Technical Memorandum

Subject: Response to MEDEP Comments
Phase 14 Solid Waste Permit Application - Volume IV
Crossroads Landfill, Norridgewock, Maine

The purpose of this memorandum is to provide responses to comments (RTCs) from the Maine Department of Environmental Protection (MEDEP) after their review of Volume IV of the Phase 14 Solid Waste Permit Application, dated 24 October 2019. MEDEP's review comments were presented in a memorandum transmitted as an attachment to an email from Linda Butler to WMDSM on 24 April 2020. The responses were prepared by Geosyntec Consultants (Geosyntec) and WMDSM. Clarifications to some of the review comments were provided by MEDEP during a conference call with WMDSM's project team on 6 March 2020. MEDEP's comments are presented below in italics followed by responses to each.

ATTACHMENT RTC#12-1
Permit Drawing - Sheet 15 (Rev1)

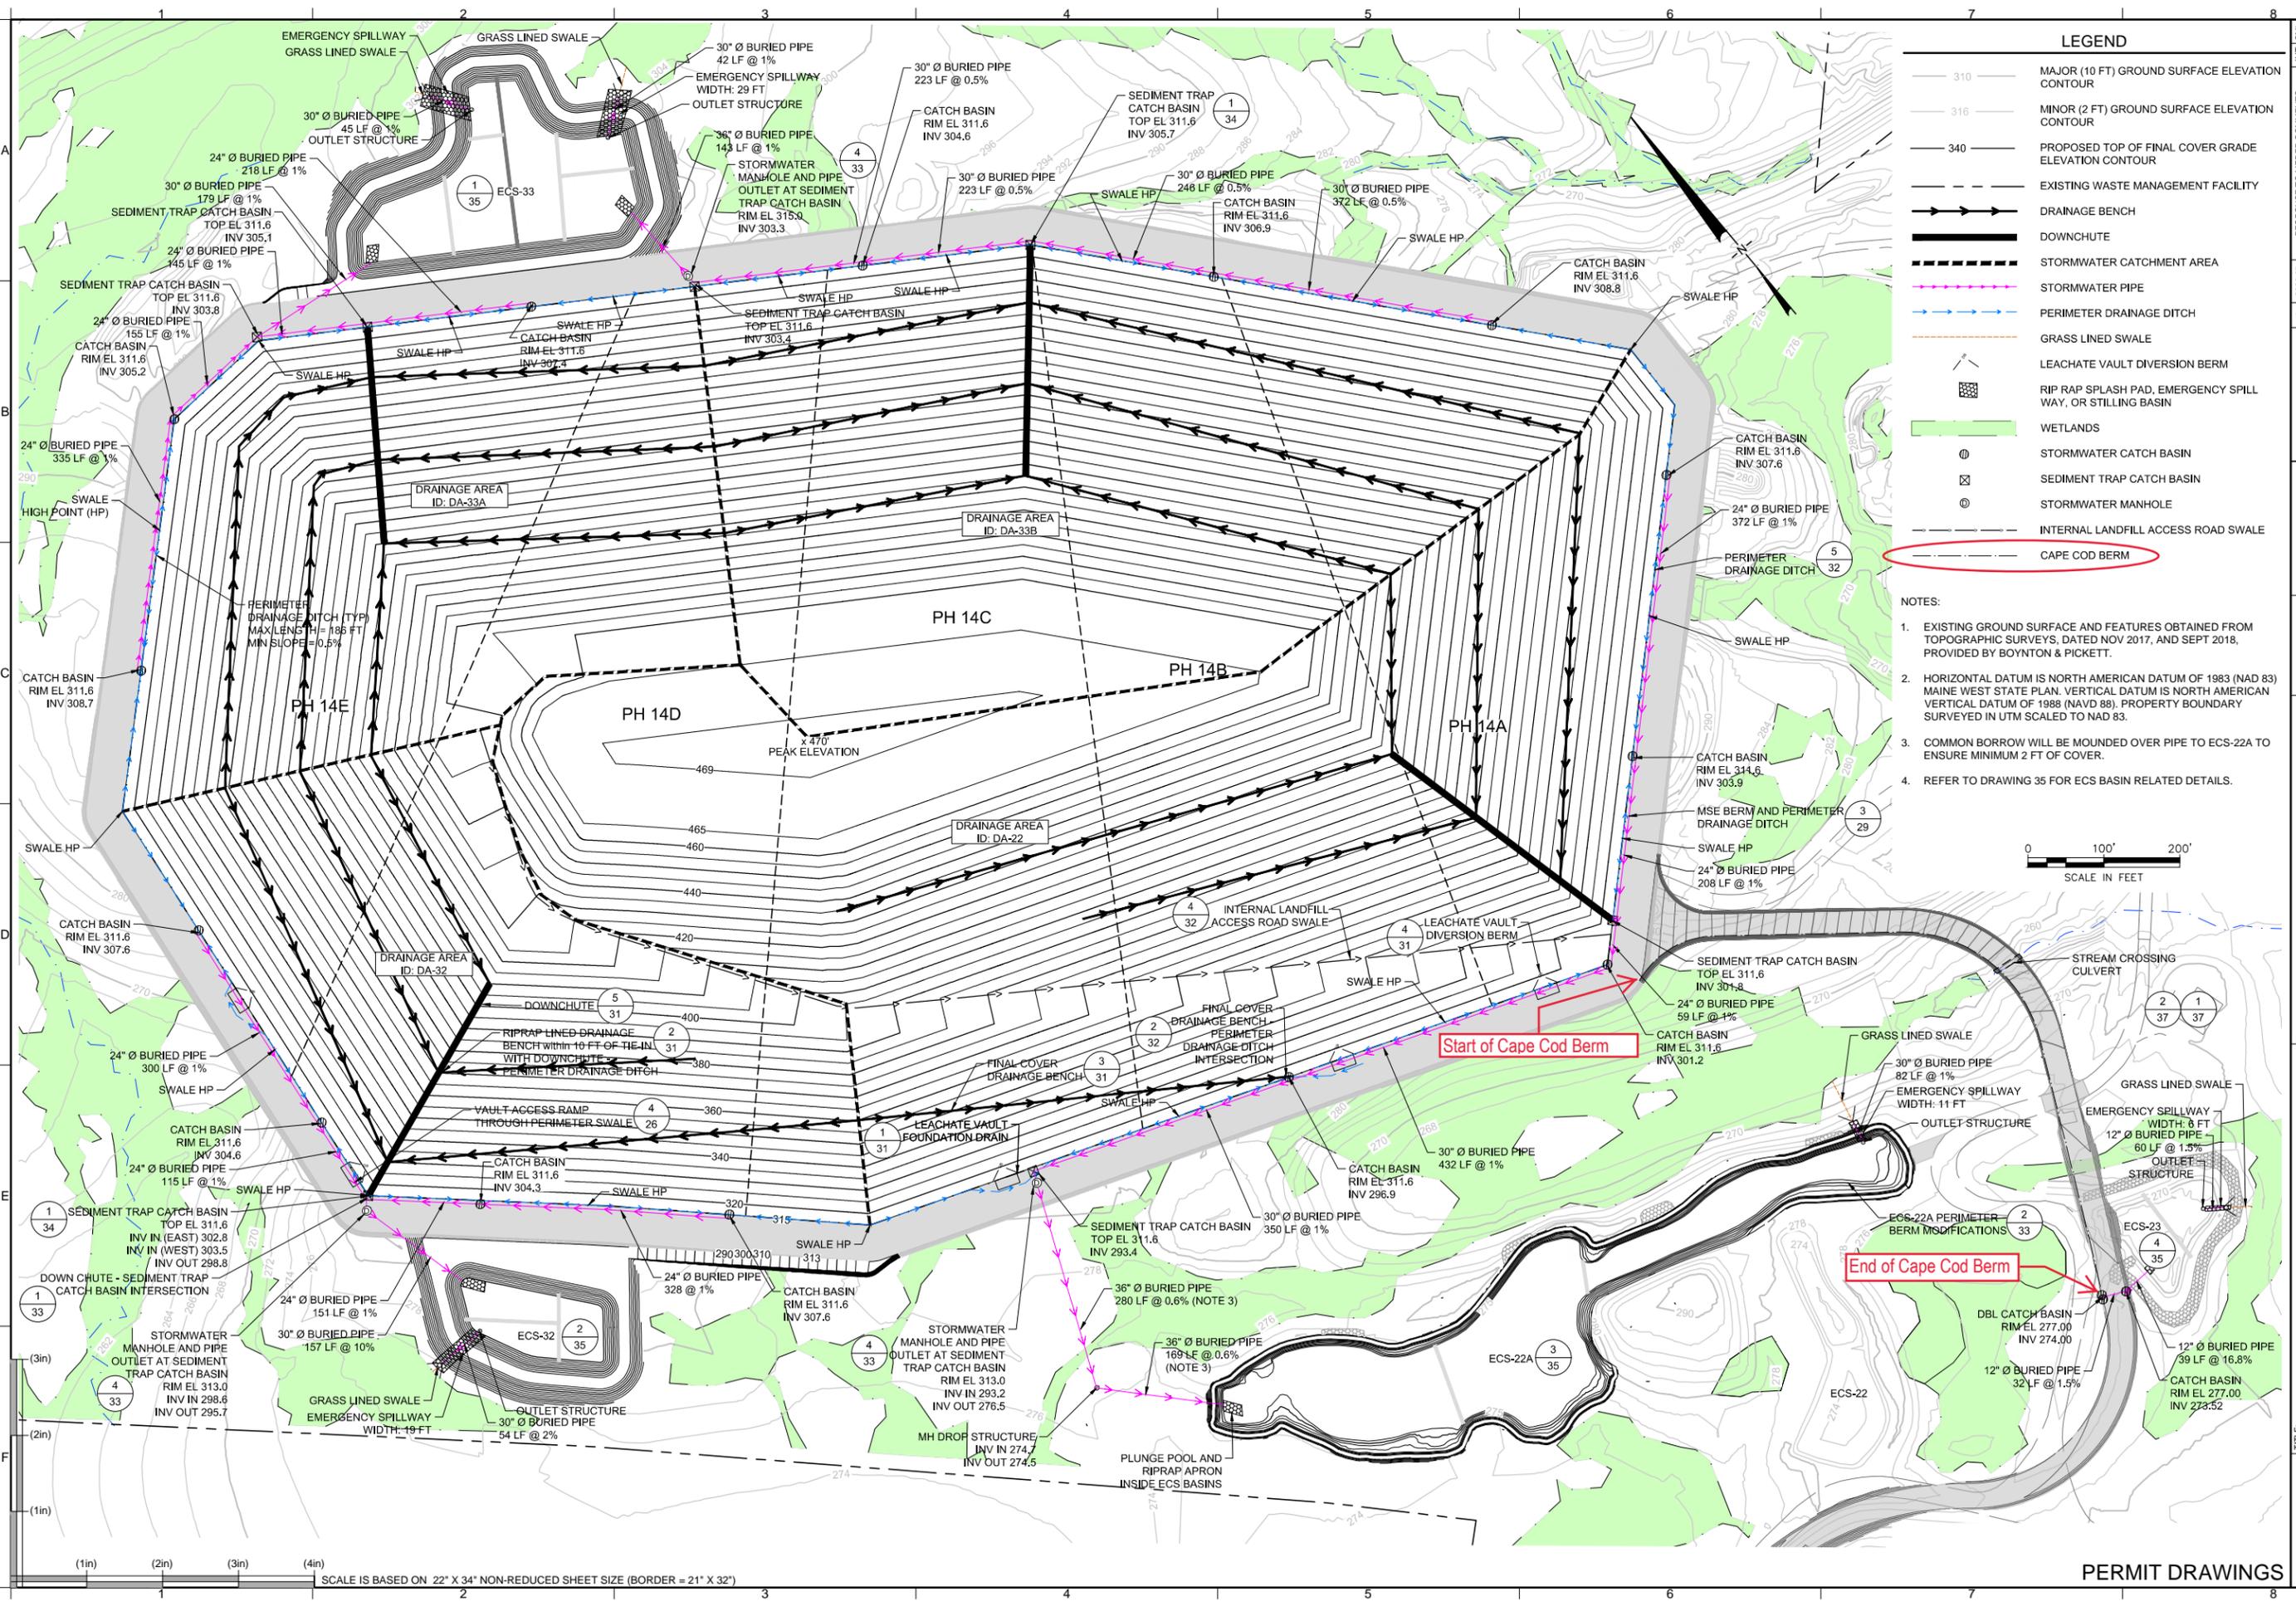
9. *Sheets 14, 15, and 35. The paved landfill access road appears go over a portion of the rip rap of ECS-23. Clarification should be provided on the details of the contact between the road and the ECS basin.*

10. *Sheet 15. The buried stormwater pipes from the perimeter drainage ditch catch basins to the ECS basins are at 1% grade except for the buried pipe along the northern perimeter which is at 0.5% and the pipe into ESC-22A at 0.6%. An explanation should be provided for the reduced pipe slopes in these areas.*

12. *Sheet 21, Detail 2. The detail shows an access road slope surface of 1% across the MSE ramp to a Cape Cod Berm on the road edge. A clarification should be provided regarding water flow discharge from the ramp, as the road surface appears to be sloped to the road's edge berm without a way for the water to leave the roadway.*

Response to Comment 9. The alignment of the road will remain as shown and the lateral extent of the rip rap at the edge of ECS-23 will be trimmed accordingly to coincide with the edge of the new road. This edit, which does not have any effect on the performance of the ECS basin, will be shown on the construction drawings for the initial phase of construction.

Response to Comment 10. The solid-waste design regulations do not require the pipes to be sloped at 1%, however, Geosyntec used 1% as a target slope for most of the perimeter pipes to simplify the design process. There are two buried pipes with longitudinal slopes that are less than 1%: the buried pipe along the northern perimeter which will be installed at 0.5% to provide the minimum soil cover requirements at the upstream manhole structure while achieving the invert elevation into the receiving basin which was established based on groundwater levels; and the buried pipe from the south perimeter out to ESC-22A which will be installed at 0.6% to reduce pipe exposure above grade while allowing the upstream end of the pipe to penetrate under the MSE berm and to discharge into ESC 22A (i.e., the minimum slope that could be fit between these two fixed end elevations). It is noted that the sizes (diameters) of both of the subject pipes were designed to provide ample flow capacity for the design-storm peak flow at the slopes of 0.5% and 0.6%, respectively.

Response to Comment 12. As indicated by the proposed road surface contours shown on Sheet 15 and in Detail 2 on Sheet 21 of the October 2019 Permit Drawings, stormwater falling on the

MSE ramp will drain via overland (sheet) flow down and toward the south gutter line of the ramp and then along the west side of the road to the double catch basin located adjacent to ECS-23. The cape cod berm will be installed along this entire edge of the ramp and road as shown in the revised Sheet 15 presented in Attachment RTC#12-1. Evaluation of a typical 10-inch wide by 8-inch tall cape cod berm indicates sufficient capacity to convey flow along the gutter line to the two double catch basins located adjacent to ECS-23. Further details of the cape cod berm will be provided in the construction packages for the initial phase of development¹.
